# Replies to committee's questions

Marco Verzocchi on behalf of the TPC electronics consortium

07 April 2020

# Questions from the committee

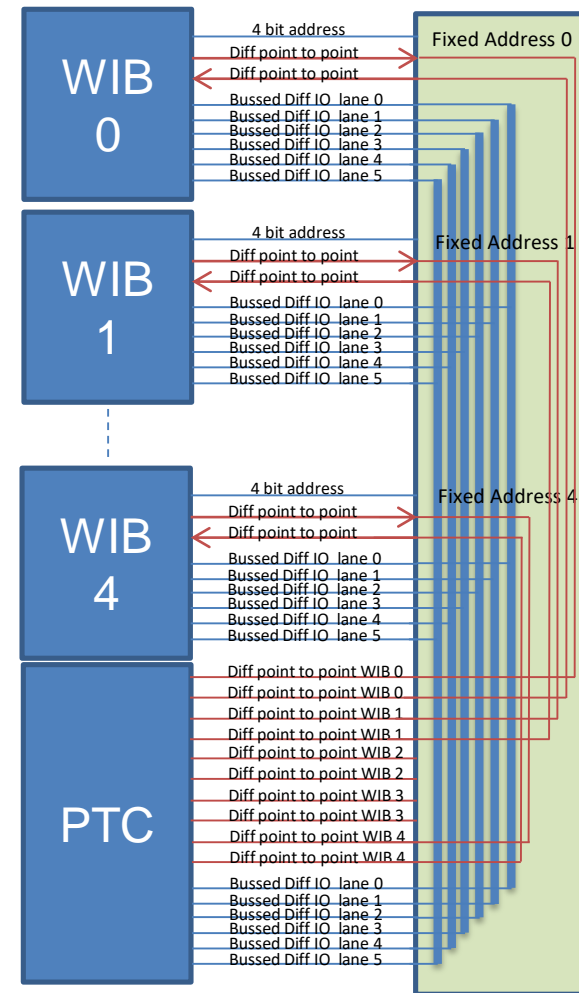
Q. Lines in the WIEC will be configured as an I2C “backplane” . If the WIBs are timing endpoints will they be able to be I2C masters and control the single optical transmitter if they are interrogated by the timing master? How long will it take for these I2C transactions to complete and the transmitter to be activated ?

A. This should work as follows:

- Timing system tells the WIB in slot x to configure for the delay measurement
  - The FPGA in the PTC sets appropriate bit in the priority encoder in such a way that the reply sent to the timing system from the WIB in slot x is selected
- Timing system sends signal to WIB in slot x, received by the FPGA there
- FPGA in WIB in slot x sends alarm to the FPGA in the PTC, then replies to the timing system with a fixed delay
- That reply is sent back to the timing system
- Further checks are performed and finally the timing system downloads the delay information on the timing endpoint
- Exact sequence needs to be discussed with the DAQ consortium

## WIB Clock Distribution

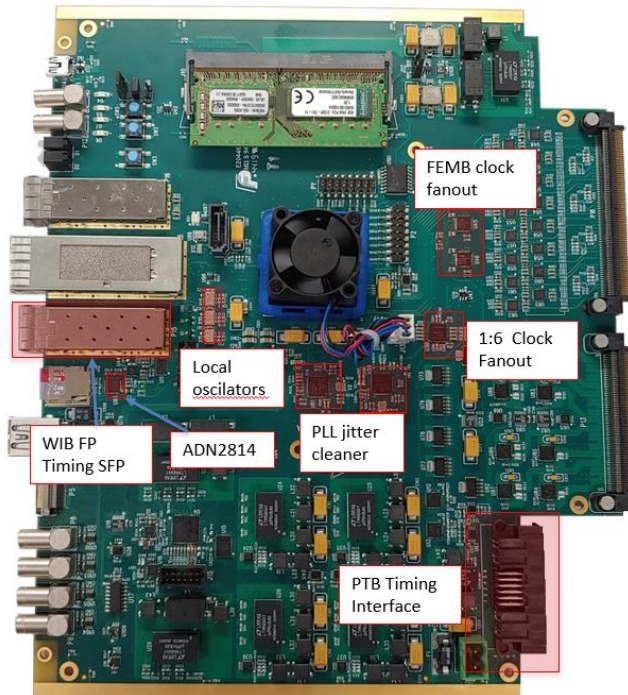
Q. It looks like p17 of [Jack's presentation on the WIB](#) has the wrong text. What text was intended to be there?

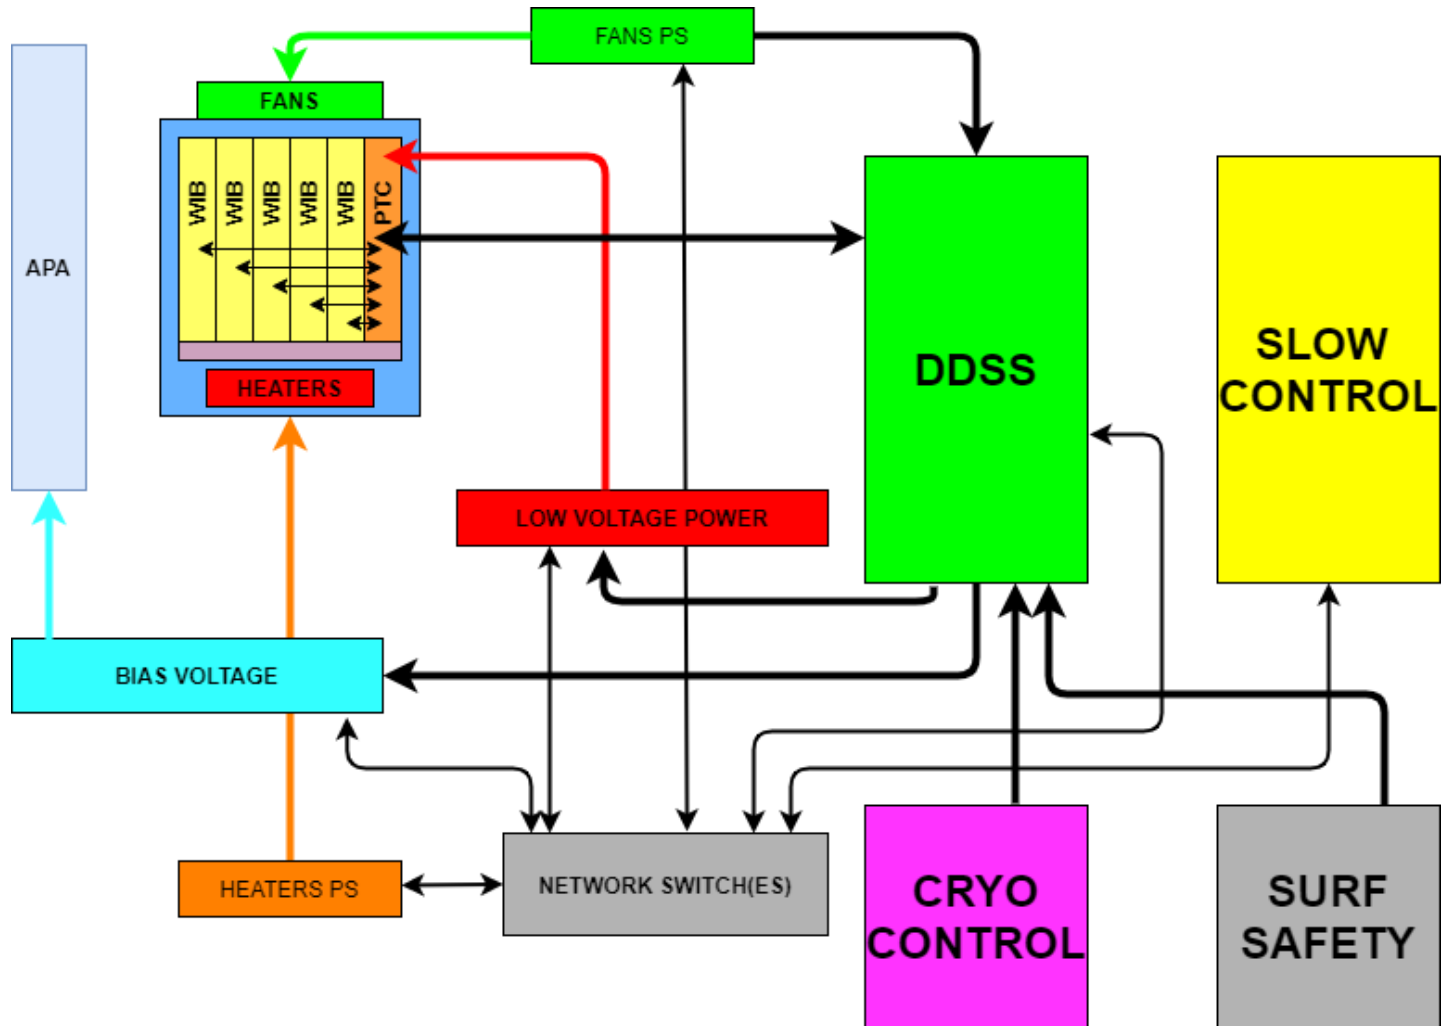
- Q. Concerning the BER, in your answer you mention that a BER of  $10^{-12}$  leads to 0.44% down time. How do you get this number when at most you lose  $10^6$  samples per day i.e. 0.5 second per day ?
- A. This number is obtained assuming that a corrupted frame in any of the 750 WIBs leads to the loss of the information for the entire detector, which is clearly a pessimistic assumption (and by the way this is wrong by a factor of 2 because the data transmission is over 2 links, which are independent). Given the nature of the data transmission between the WIBs and FELIX, with idle patterns being sent after frame, a simple non-repeated bit error in the WIB to FELIX data transmission (which is detected using the checksum at the end of a frame) introduces a negligible dead time.
